4001 S WILLOW ST

RECOMMENDATION PACKET
MEETING DATE — AUGUST 30th, 2022

3038001-LU

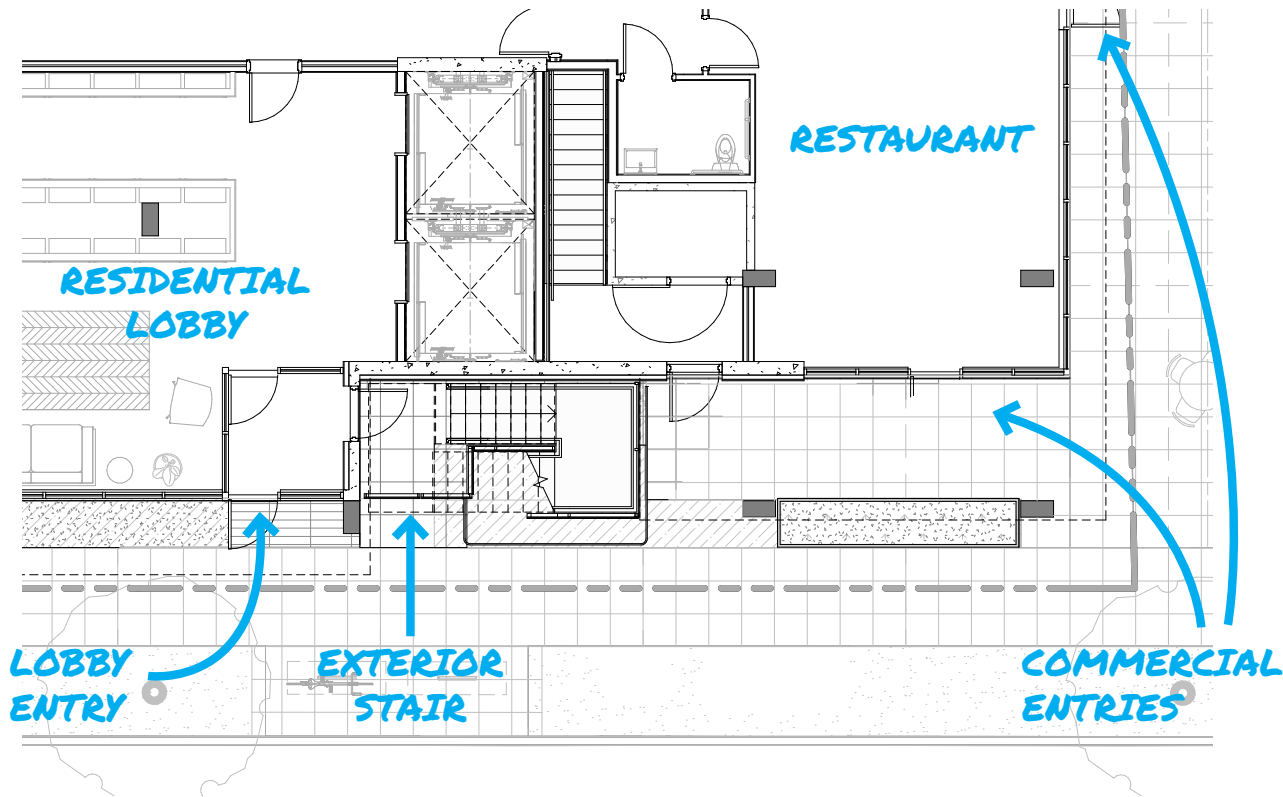
The Board was supportive of the exterior stair element proposed in Option C and recognizes the importance of the articulation of the exterior stair as a prominent massing element to the overall success of the massing concept. (DC2-A. Massing, CS2-III. Corner Lots)

The exterior stair has been developed since the EDG phase to emphasize its role in balancing the two primary building volumes. Cedar siding has been added to to the back wall to provide a warmer material experience that also ties into the residential units at grade along Willow Street, and reinforces the gasket-like quality of the stair. A canopy with cedar soffit has been added to define the top edge of the stair and reinforce the overall massing scheme.

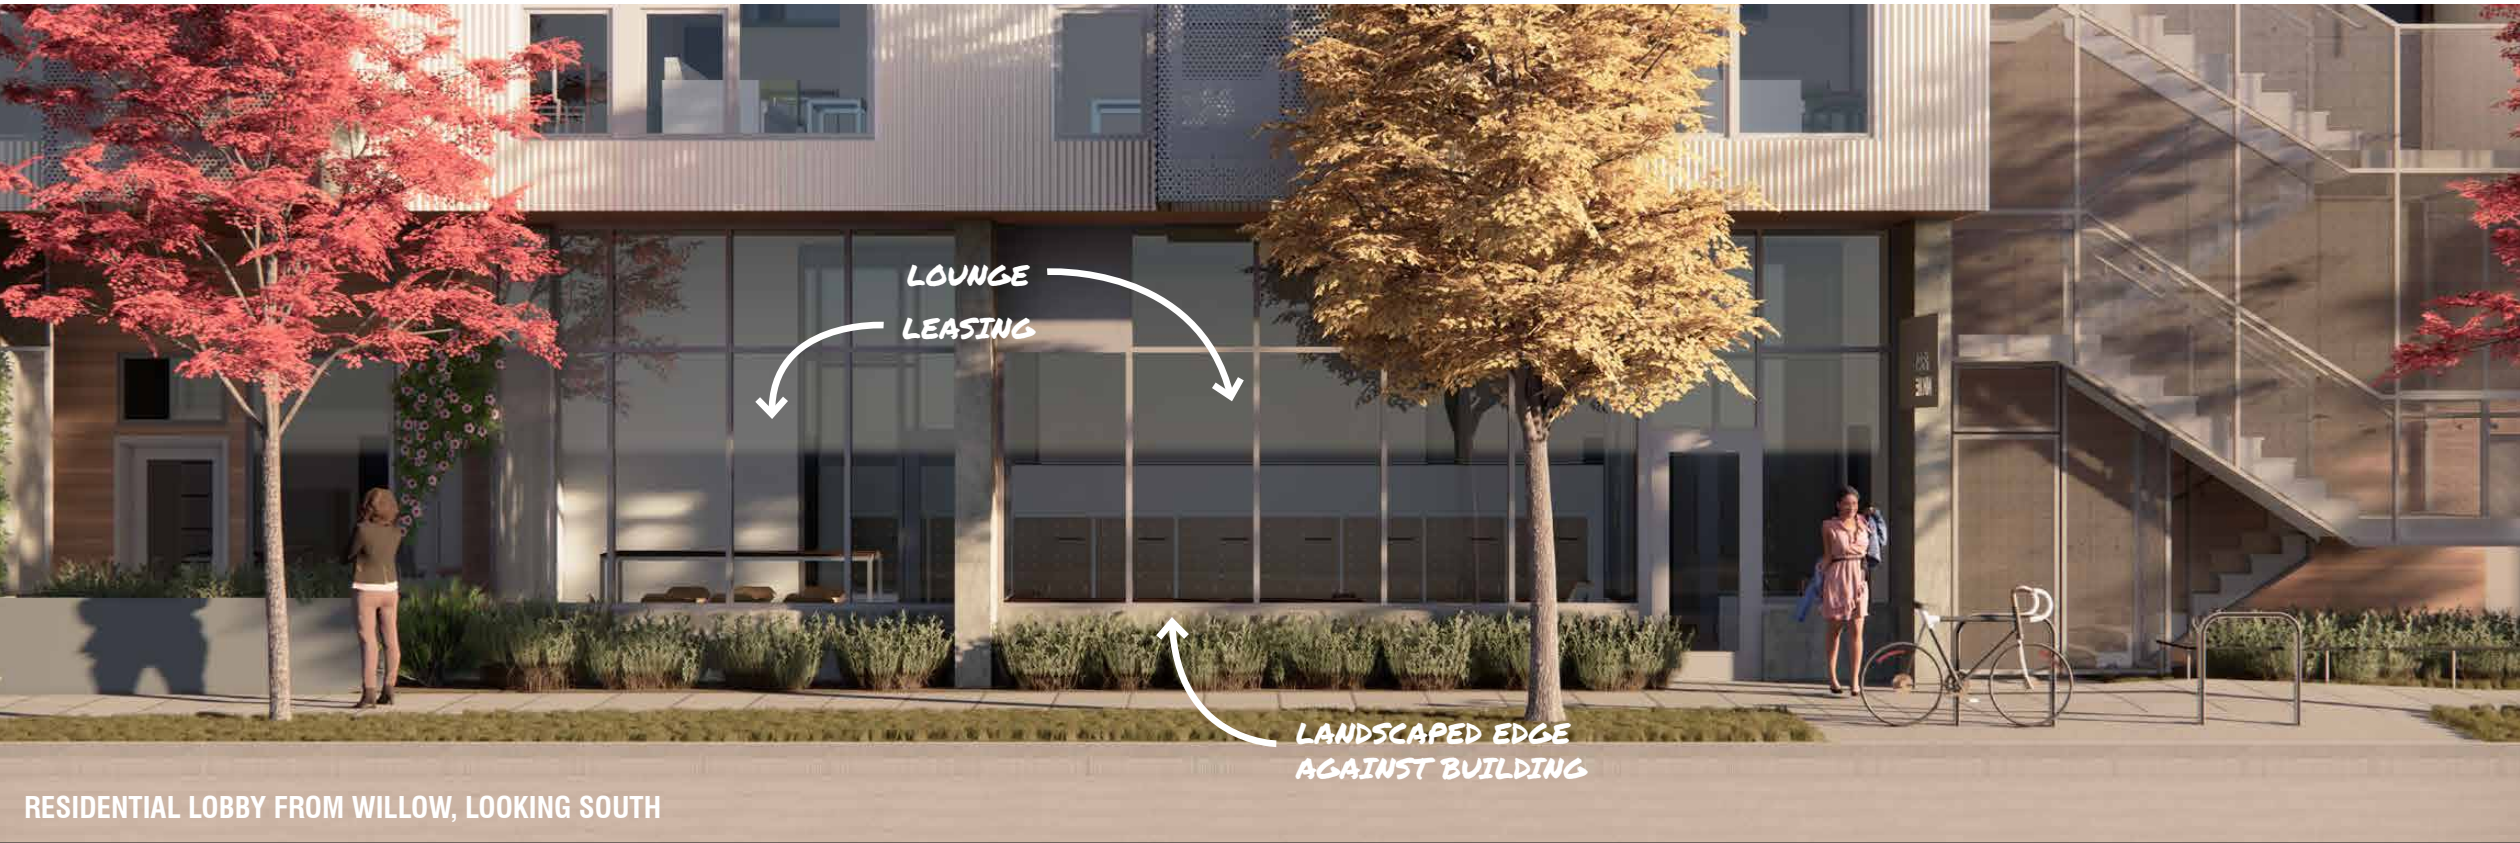
The Board supported the transparency of the commercial space and residential lobby and expects this element to be maintained. (DC2-A Massing, CS2-III Corner Lots, DC2-B Architectural and Façade Composition)

Both the residential lobby and the commercial space maintain a high degree of transparency, each adapted to its context. The commercial space opens directly onto a hardscaped public plaza with a landscaped edge along MLK; the lobby is organized with a lounge and leasing office along the sidewalk to promote an active street presence.

VIEW OF RESIDENTIAL UNITS ALONG S. WILLOW ST.

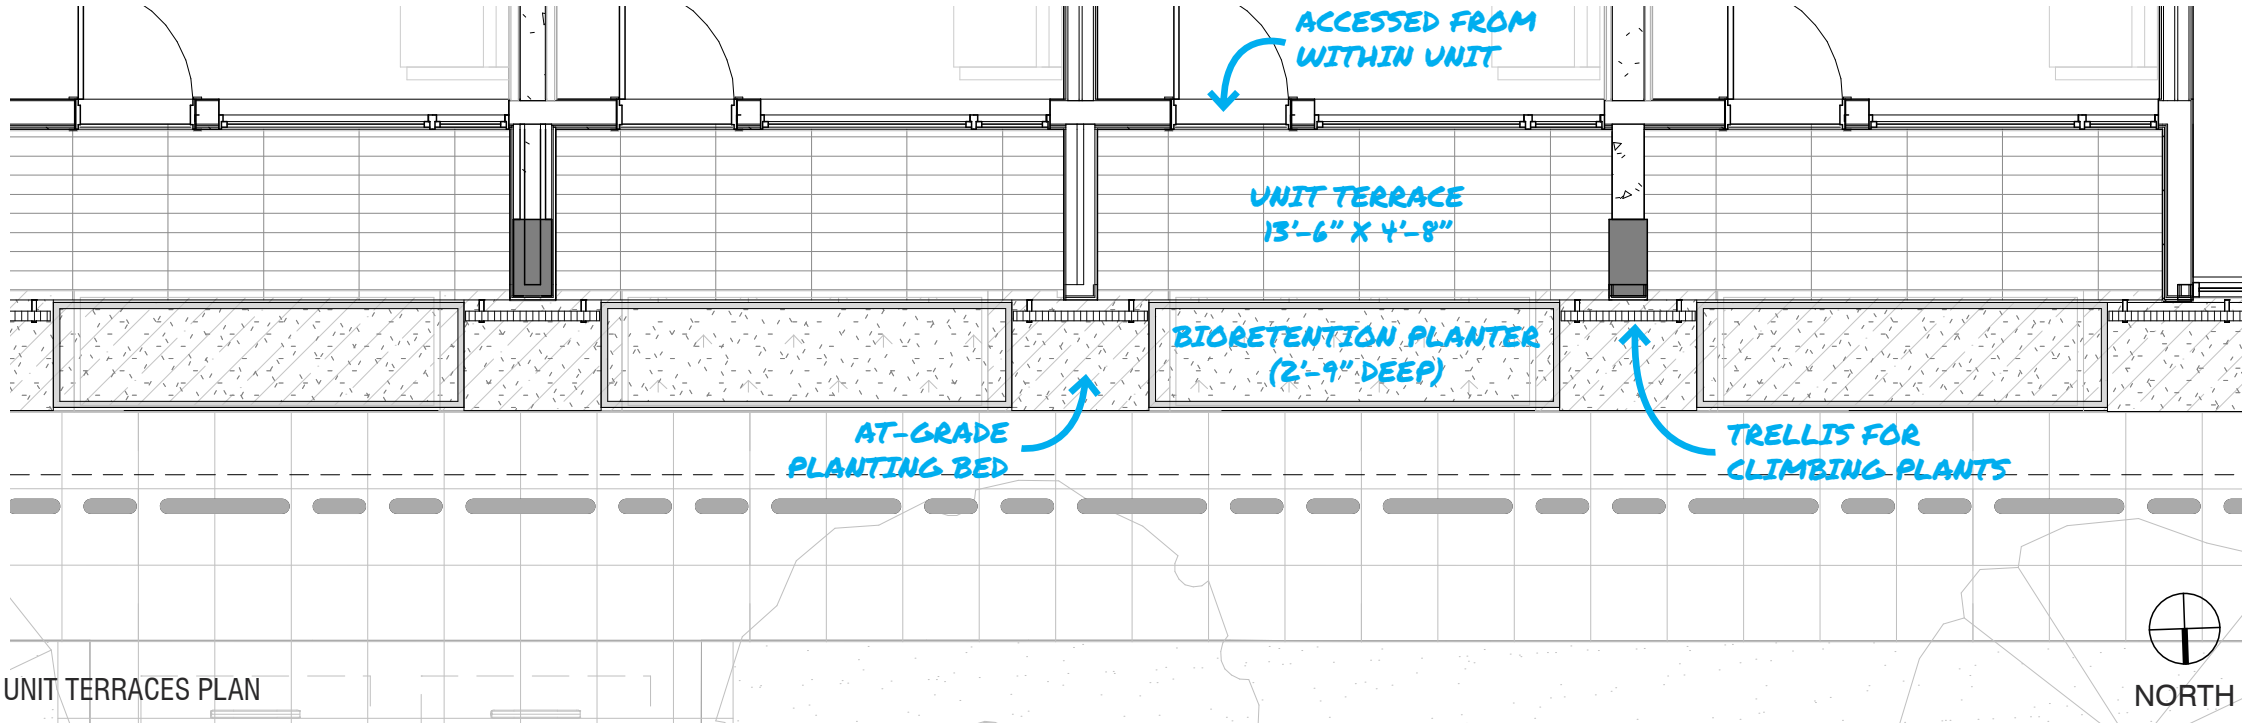
The Board prioritized Othello Neighborhood Design Guidelines PL2-I and PL3-III and supported the finer-grain detail of the residential entries along Willow St. indicated in the design development images. The Board expects to see rich articulation of the ground level. (DC2-B Architectural and Façade Composition, PL2-I Personal Safety and Security, PL3-III Transition Between Residence and Street)

Residential open spaces now have bioplanters serving as physical barrier to create transition between private residences and the public street. The different layers of planting creates visual complexity that enhances the massing depth and facade composition. The residential open spaces provide opportunities for social interaction among residents and neighbors.

PERSPECTIVE VIEW OF SOUTH ELEVATION FROM ACROSS MLK, FACING NORTHEAST

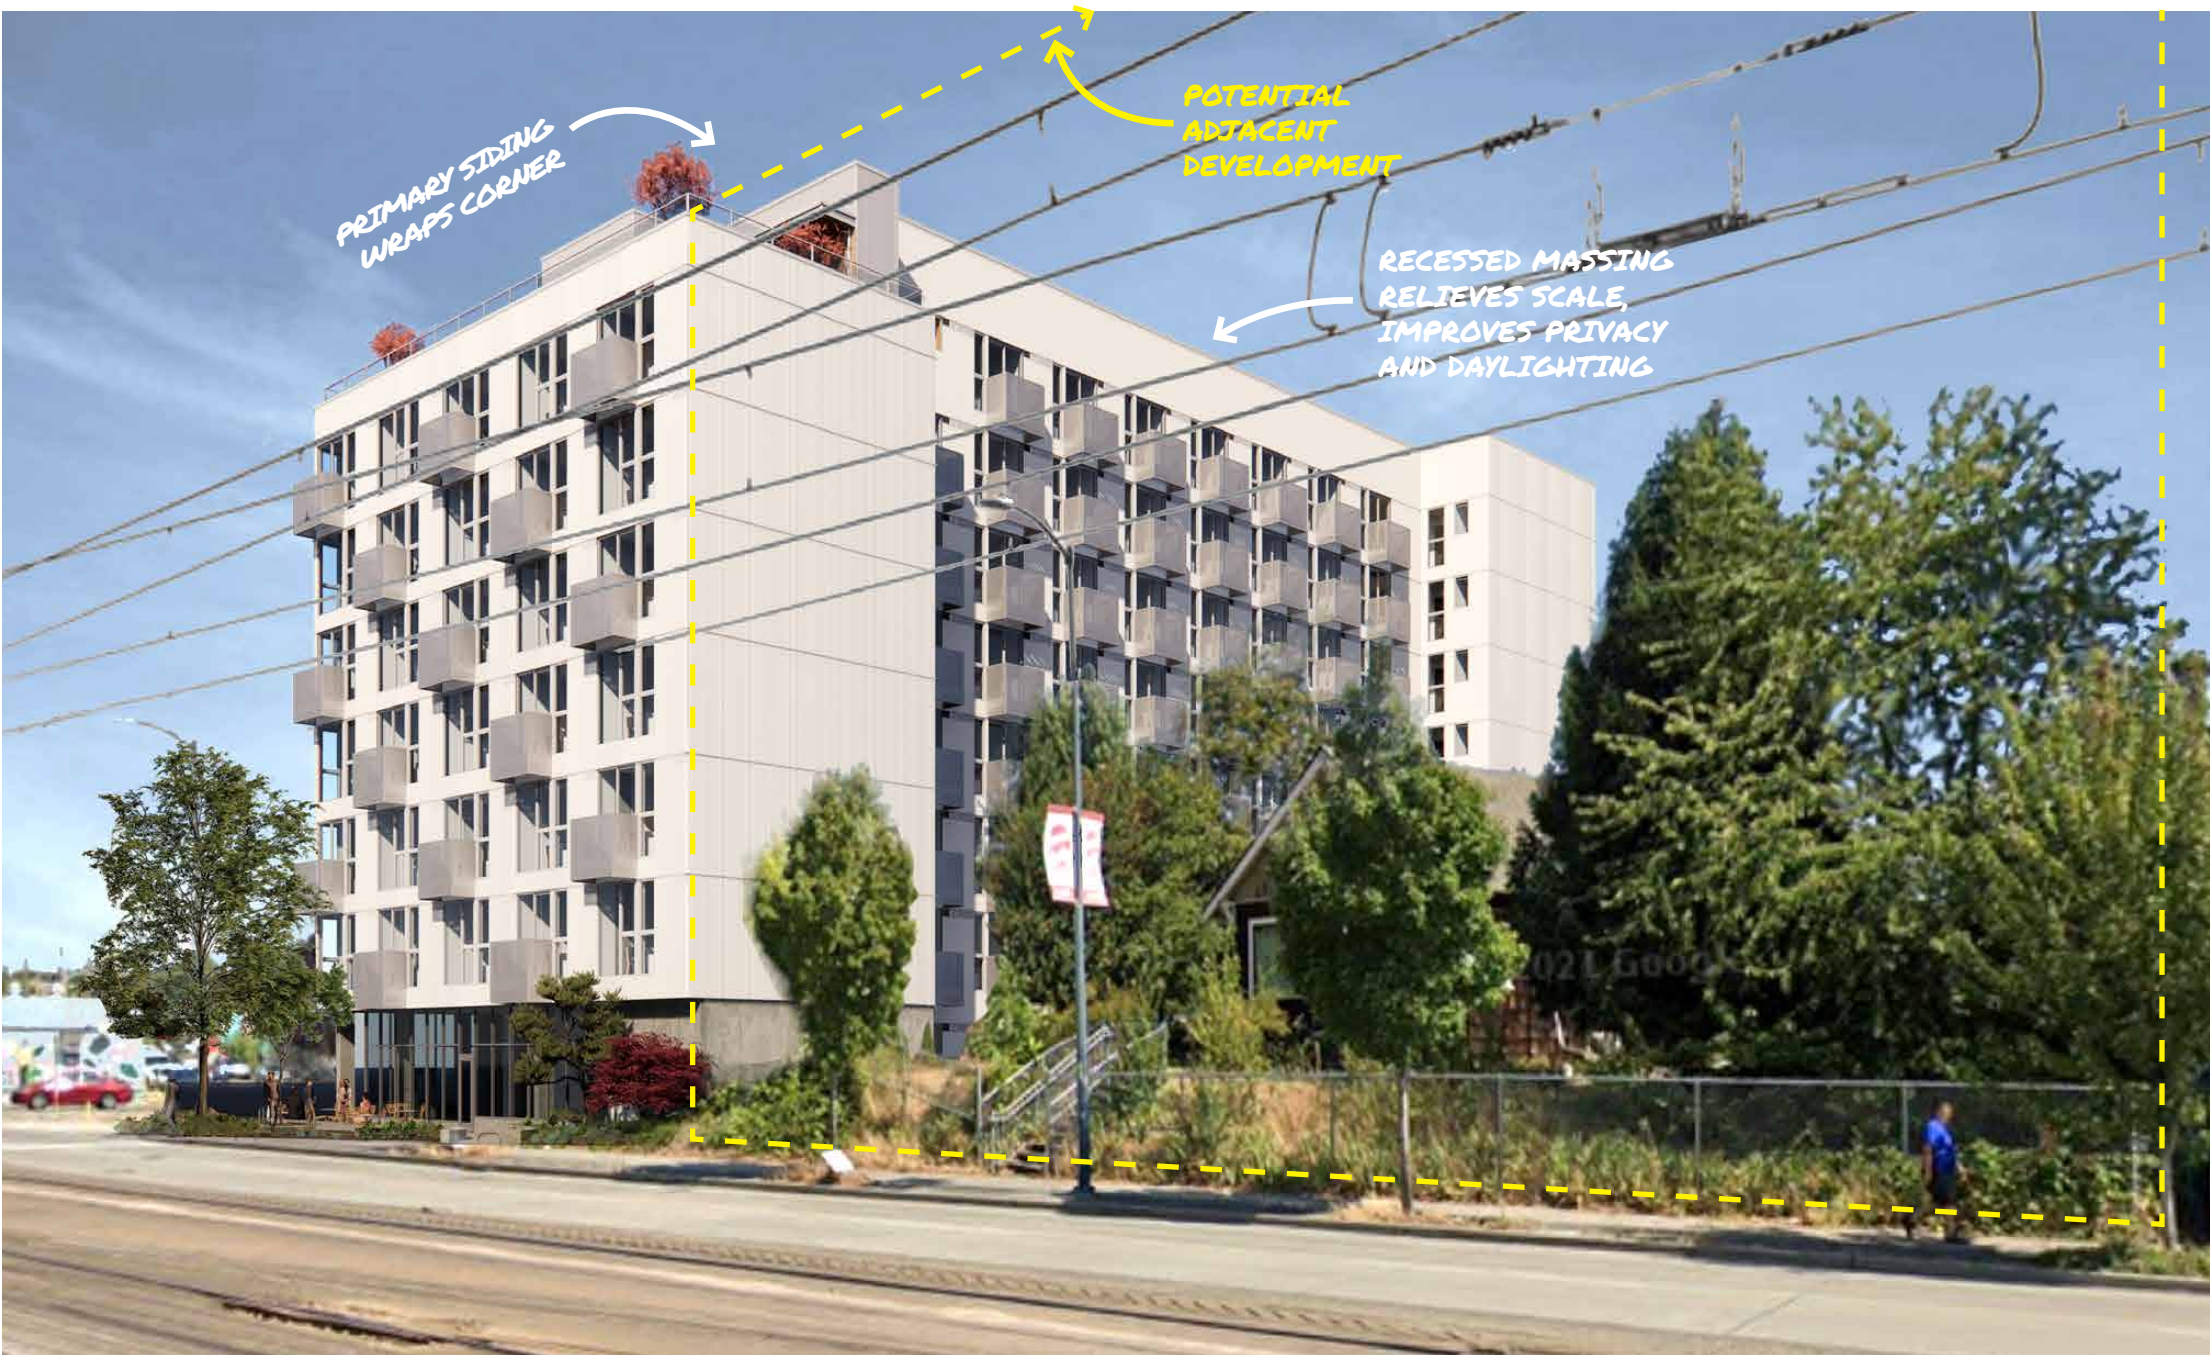
The Board appreciated that Option C orients the units in a manner which minimizes blank wall area and reduces privacy impacts (*DC2-A Massing. DC2-B Architectural and Facade Composition*).

The Board also supported the location and shift of the massing away from the south property line to provide greater light and air to the south-facing units and massing relief to adjacent development. (*DC2-A Massing. CS2-D-1 Existing development and Zoning*)

As presented at EDG, blank walls are located at the south, with south-facing units set back 12’-6” from that property line.

The primary siding — a tightly-corrugated white metal with an opalescent finish — wraps the corners at the east and west, providing visual interest for the blank walls through a play of shadow and light, as well as supporting the overall “whole building” massing scheme. This approach treats these wall segments as subtle and quiet elements, focusing attention on the significant massing moves and primary street elevations.

Blank walls have been minimized in size and located in less visible locations, where future development is anticipated, consistent with *DC2-B-2. Blank Walls*.
